Product Change Notification

Product Series Involved: 34 Series Relay, 38 Series Module, 39 Series Module

Type of Change: Major

Key Change: Aesthetical

Current Product

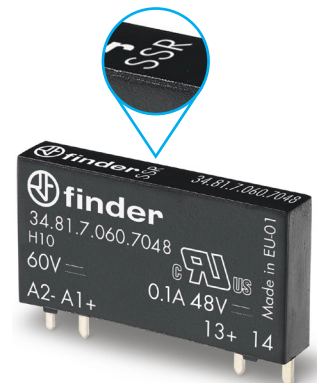
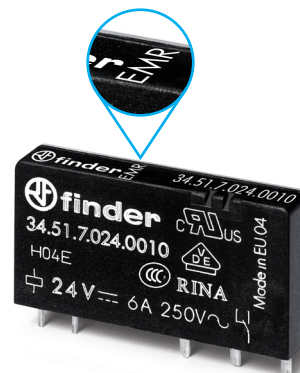
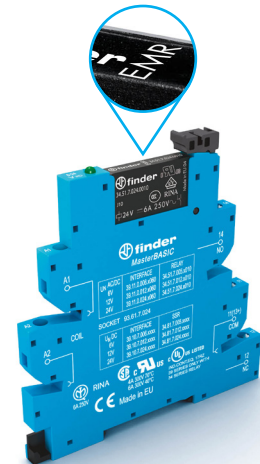
Reason - Finder Relays has identified and implemented a new and improved manufacturing process moving away from ultrasonic welding to a modern laser welding technique. This new procedure requires Finder Relays to change the plastics used in construction of the housing, which ultimately changes the housing color. Form, fit, function, and interchangeability remain unchanged.

Old 34 Series – White housing for EMR (electro-mechanical relays) or black housing for SSR (solid state relays) with specifications and number printed on the side of the relay. No identification printed on the top.

New 34 Series – Black housing for both EMR (electro-mechanical relay) and SSR (solid state relay). Printing is located on the side of the relay as well as additional identification now on the top. The improved printing on the top will state Finder; EMR or SSR; and full part number. The EMR relay will also include a translucent back cover.
